HARROW COUNCIL

SUPPLEMENTAL ADDENDUM

PLANNING COMMITTEE

DATE: 09 December 2020

Replace the site plan (page 153) with the following:

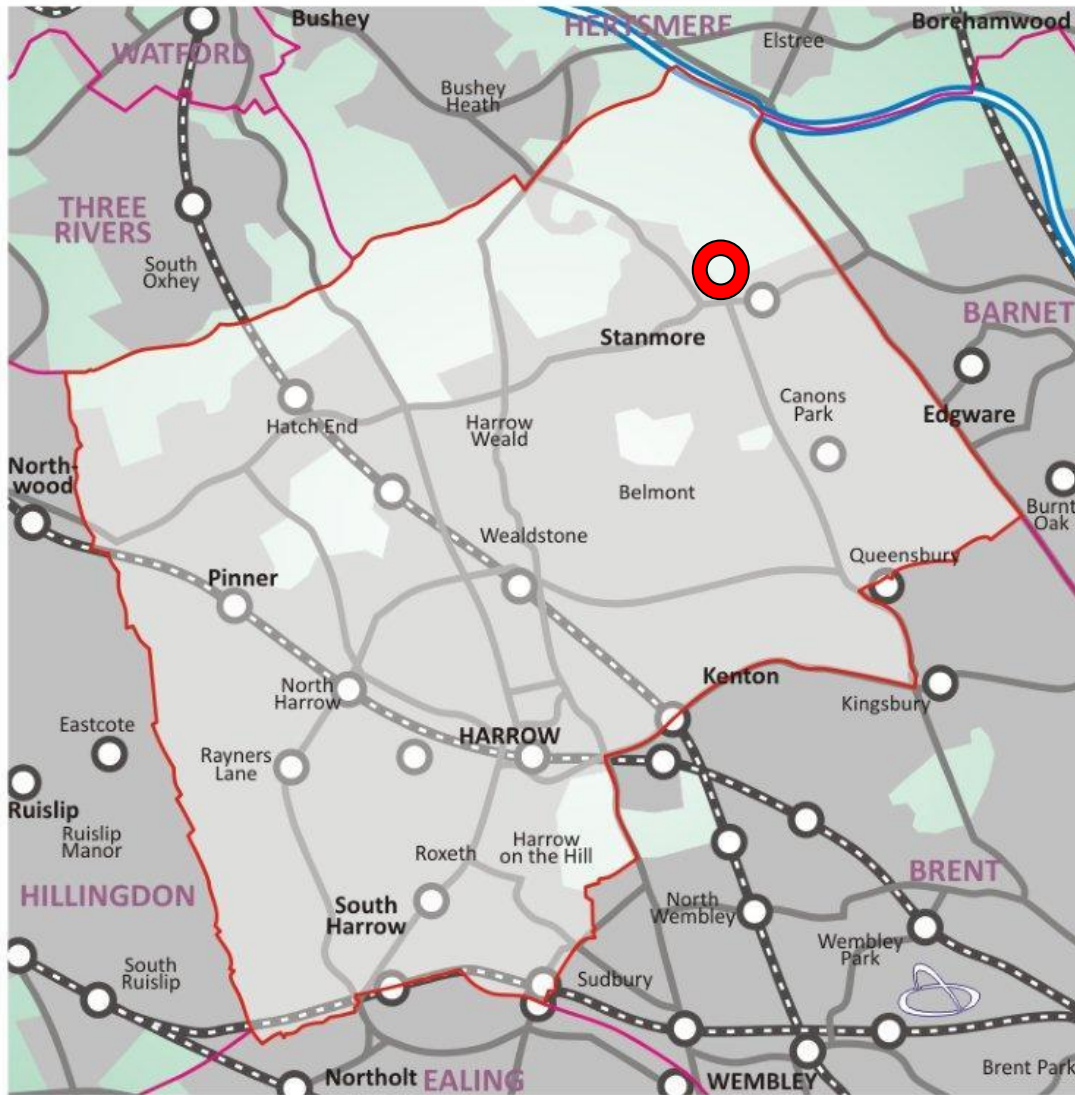
Addendum Item 1:
